6906

3/4" IMPACT WRENCH

SERVICE CHANGES

1. Changes on Washer

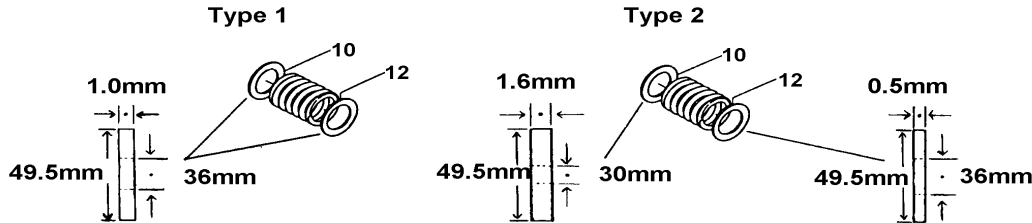
Item No.	Description	Type 1	Type 2
10	Flat Washer	253182-9	253764-7
12	Flat Washer	253182-9	253765-5
	Serial No.	~ 6809E	6810E ~

Above parts are completely interchangeable as a set.

2. Changes on Internal Gear

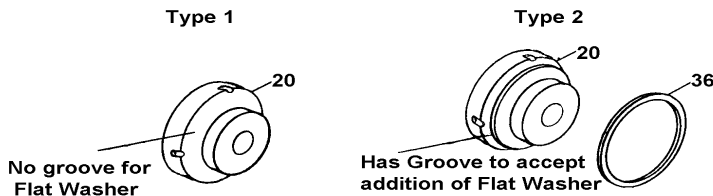
Item No.	Description	Type 1	Type 2
20	Internal Gear	221242-5 (N/A)	221242-5A
36	Flat Washer 65	-----	253774-4

Above parts are completely interchangeable as a set.

3. Changes on Anvil

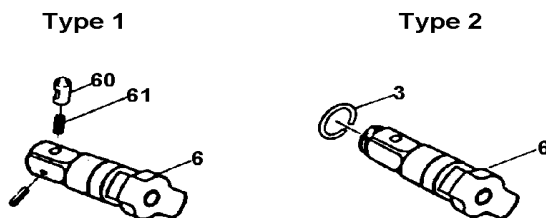
Item No.	Description	Type 1	Type 2	Type 3
3	Ring Spring 16	-----	231920-9	231920-9 (component of item no. 6)
6	Anvil / Anvil Assy	325317-3	325586-6	134946-9 (Inc.item no.3)
60	Pin 7	231157-8 (N/L/A)		-----
61	Compression Spring	256710-9		-----
62	Pin 2	256710-9 (N/L/A)		-----
	Serial No.	~ 10254E	~ 10255E - 151572E	151573E ~

Above parts are completely interchangeable as a set.
